VSP-31
August 7, 1981

VENDOR SERVICE PUBLICATION

Subject: Bendix Service Bulletin No. 618
(Replacement or inspection of distributor gears
in D-3200 series pressurized (blue) magnetos.

Models Affected: PA-31-350 Chieftain

Figure 1. Location of "x" on Identification Plate

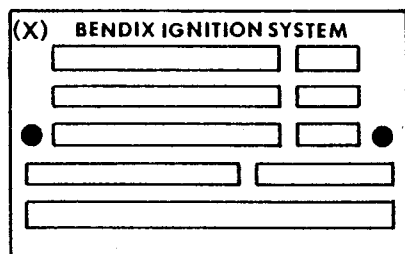
1. All subject magnetos with over 100 operating hours must have the distributor gears replaced or inspected prior to further flight, unless the magneto is identified by the letter "x" in the upper left corner of the identification plate (see figure 1). The "x" on the identification plate indicates previous compliance with this Service Bulletin.

5. Reassemble the distributor block with new serviceable gears and reassemble the magneto.
6. After installing new serviceable gears, identify the magneto by stamping the letter "x" in the upper left corner of the identification plate, before the word "Bendix" (see figure 1).

Figure 2. Checking For Loose Electrode

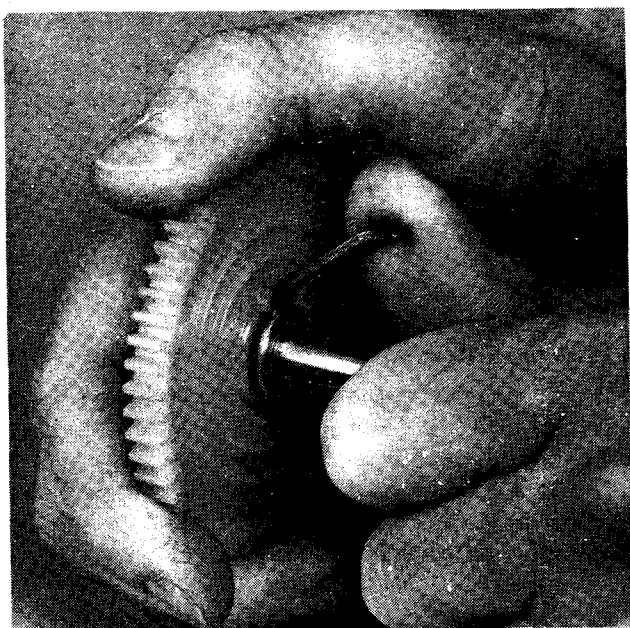
9. Inspect each gear for a loose electrode by grasping the gear firmly in one hand and alternately exerting clockwise and counterclockwise force against the electrode with maximum hand pressure. This should be done in a manner that would attempt to pivot the electrode around the axle (see figure 2). If any movement between the electrode and gear is detected, the gear must be discarded and replaced with a serviceable gear.
